D2 Subway Urban Design Process & Focus Area Summary Report

March 2020

First Draft - 20% Submittal

Commerce Focus Area Coordination

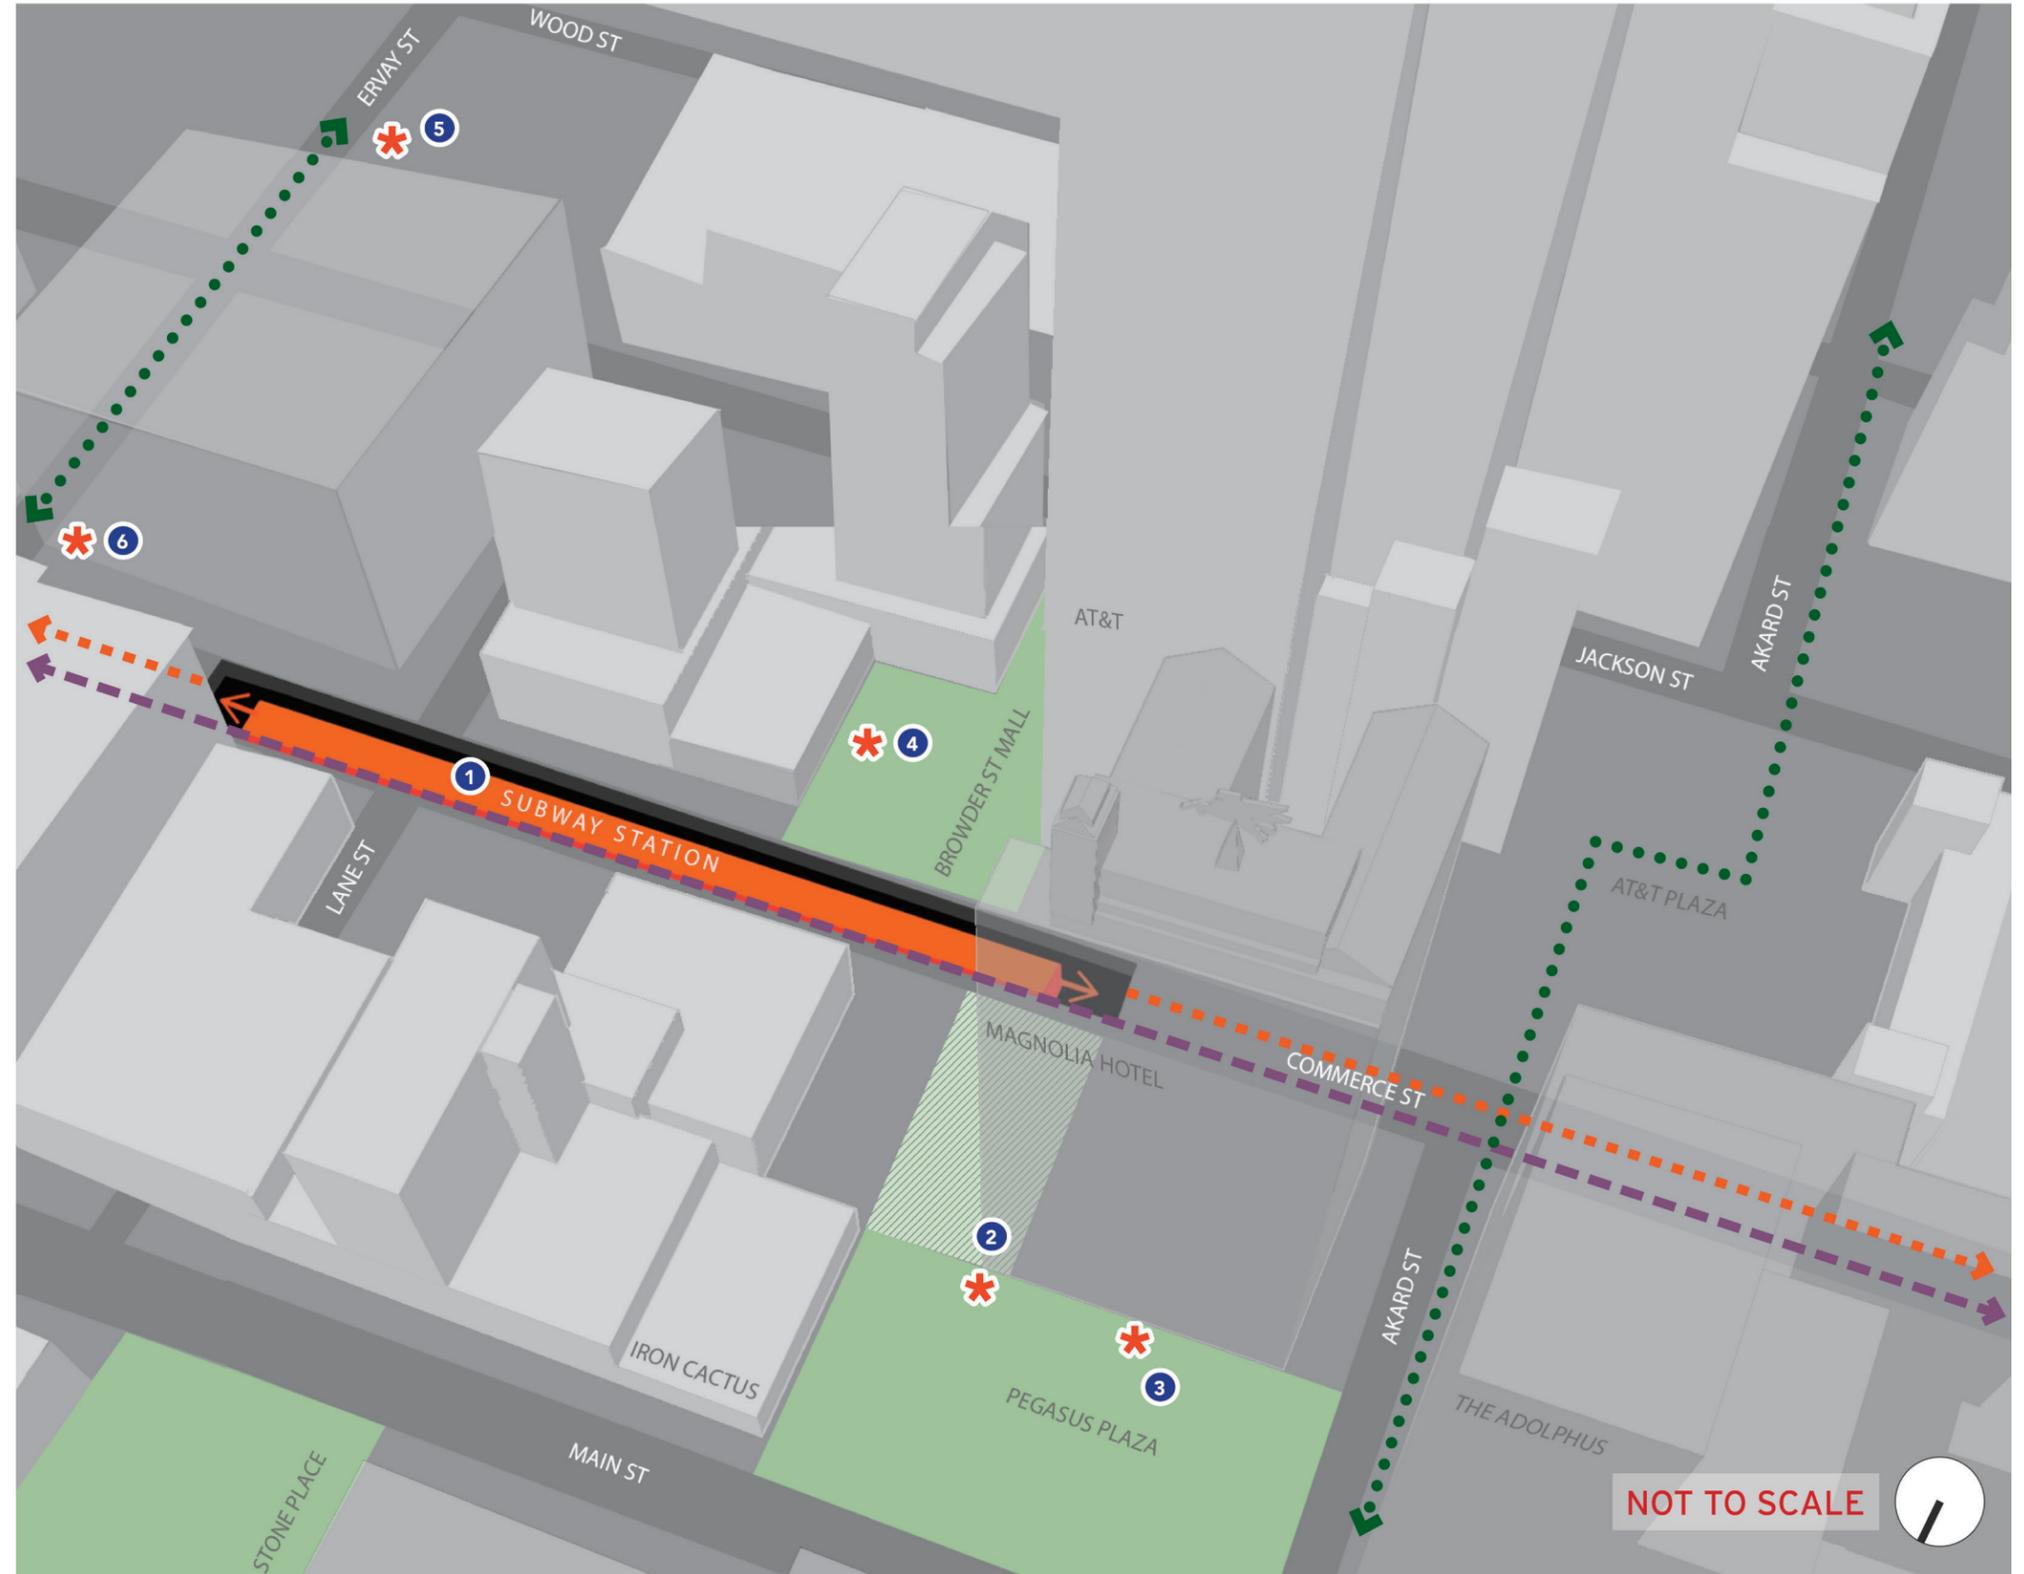
- 4 A third access point in the vicinity of the Browder Street Mall could provide an additional entry into the subway. The design would consider a smaller footprint and possibly incorporate needed tunnel ventilation all designed to keep within the aesthetic of the smaller space and complement the scale of services like ground floor retail and restaurant dining surrounding it.

- 5 Stakeholders indicated the potential for a portal in the at grade parking currently bound by Jackson, Ervay and Wood Streets and the Interurban Building Apartments. This portal would be located in the northeast corner at Jackson and Ervay Streets and provide important pedestrian connection to the north and south. Stakeholders felt a portal location in this area built with the flexibility to complement future multi-story development would be encouraged.

- 6 Secondary to the portal listed above, stakeholders discussed the possibility of an integral portal entry at the first floor of the existing garage bound by Lane, Commerce, Jackson and Ervay Streets. This, and the Browder Street Mall portal, would provide riders access to Neiman Marcus and other commercial and business destinations.

Design in this Focus Area is challenging in part due to the vibrancy and development along Commerce Street. There is very little unused or unplanned space. Based on feedback from stakeholders in the Focus Area meeting held August 22, 2018, Akard Street and Ervay Street serve as strong pedestrian corridor connections running north and south in the CBD. Placing the station below Commerce Street and providing access to both Akard Street and Ervay Street via headhouse or pedestrian portals is preferred.

The architectural study was created to address the stakeholder's desires to provide pedestrian access from the station to Ervay Street to the north and south. Options for stair and elevator access on Commerce Street were proposed where currently a vehicular travel lane exists. The photos beside the study indicate a conceptual progression from the existing condition to a potential pedestrian portal. The sketch simulation is provided to show scale spatially only and does not reflect portal or elevator design or materials. For current design of the pedestrian portal in this location reference architecture plans, cross sections and details.

Good Latimer Expy Cross Sections

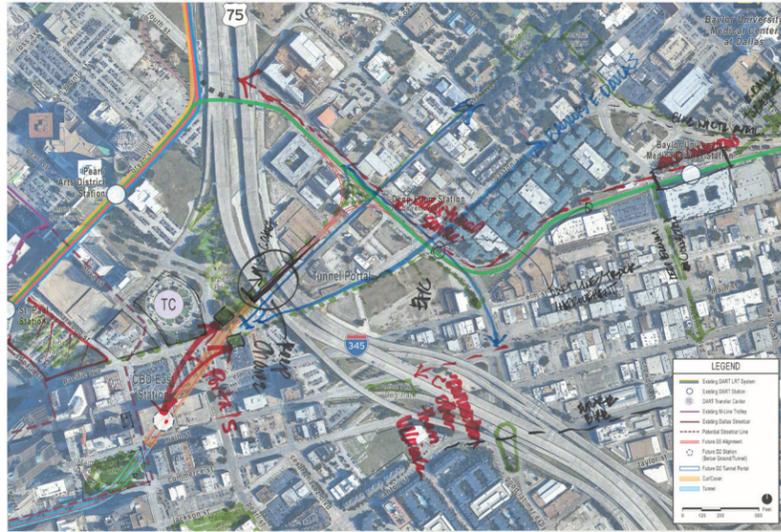
- 1 Stakeholders support the reconstruction of Good Latimer from North Central Expressway (I-345 frontage road) to the north to Elm Street to the south. North and south bound lanes of traffic on Good Latimer would be rebuilt adjacent to one another. Existing DART tracks would be removed from the center of Good Latimer and placed to the west. This will provide a shorter crossing distance for pedestrians. DART will prepare Complete Street cross sections of Good Latimer in this area for review and stakeholder feedback.

- 5 Based on the vision of the Dallas 360 Plan for this Catalytic Development Area, stakeholders support very strong pedestrian connections adjacent to the tunnel portal. This would connect Swiss Avenue east of Good Latimer to Carpenter Park west of Cesar Chavez, continuing on to Pacific Plaza.

- 6 With the loss of the Deep Ellum Station, DART should consider improvements at the existing Baylor Station. Improved security measures are a desire of stakeholders as well as improved access into Deep Ellum streets to the south from the existing Baylor Station. Possibly renaming the station 'Baylor/Deep Ellum' so as to provide intuitive arrival/destination information should be considered.

The Deep Ellum Foundation formed a Good Latimer Committee to review design in greater detail with regards to multi-modal connections, conceptual development of the pedestrian and street connections, and ultimate configuration of Good Latimer Expy.

The area around Swiss Avenue east of I-345 remains the preferred location for the tunnel portal placement and wye track by majority consensus. The DART Board of directors and Dallas City Council approved resolutions to support the LPA that shows the tunnel portal south of Swiss Avenue. A series of concepts on the following pages were developed to show potential city street grid connections, pedestrian access and future development as guided by the Dallas 360 Plan.

Keeping the stakeholders' desires in mind to maintain Good Latimer Expy traffic flow north and south, plans were developed that show the D2 tracks in the center of Good Latimer Expy and on the west side of Good Latimer Expy. Maintaining the tracks in the center of Good Latimer Expy and separating northbound and southbound Good Latimer Expy as it exists today was seen by some stakeholders as beneficial based on southbound right turn connections to private properties to the west. This center-running option however, increases the number of track crossings, which would in turn affect signalization at intersections and automobile queuing.
